MANDATORY**SERVICE BULLETIN**

DATE: October 5, 2015
 Service Bulletin No. 621B
 (Supersedes all versions of Service Bulletin No. 621A)
 Engineering Aspects are
 FAA Approved

SUBJECT: Diaphragm-Type Fuel Pump Replacement

Figure 1
Manufacturer's Code Location on
Fuel Pump P/Ns 62B26931 and LW-16335

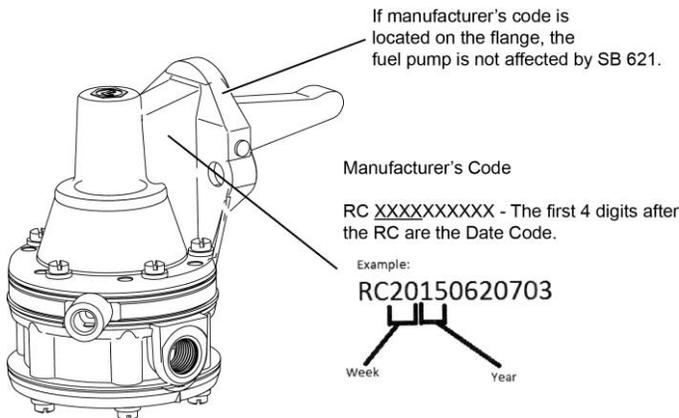
NOTICE: Each fuel pump has a 13-digit alphanumeric manufacturer's code, which begins with two letters as shown in the example in Figure 1. The alphanumeric characters in the manufacturer's code and its location on the fuel pump will help identify the fuel pumps affected by this Service Bulletin. The first two characters in the example manufacturer's code RC20150620703 in Figure 1 are **RC**. The next two numbers **20** identify the manufacturing week of the year as **20** and **15** is the year. The manufacturer's code is on the fuel pump flange or on the web as shown in Figure 1. If the manufacturer's code is on the flange as in the example in Figure 2, the fuel pump is not affected by this Service Bulletin.

1. If the fuel pump is Lycoming part number 62B26931 or LW-16335 (ordered and sold as LW-16335-S but marked on fuel pump as LW-16335).
2. If the manufacturer's code is not on the flange but is on the web or other parts of the fuel pump.
3. If the fuel pump has **RC** (Figure 1) as the first two letters of the manufacturer's code.
4. If the manufacturer's code identifies the fuel pump as manufactured before, up to, and including the 25th week of 2015.

If any fuel pump meets **all** the criteria above, remove the fuel pump from the engine or from the spares inventory and:

- A. Review your records to identify shipping dates of the serial numbers of any of the affected fuel pumps.
- B. Return all affected fuel pumps to Lycoming Engines with a copy of this Service Bulletin and file a warranty claim per the warranty procedure herein.
- C. Record removal of the fuel pump installed on the engine in the engine logbook.
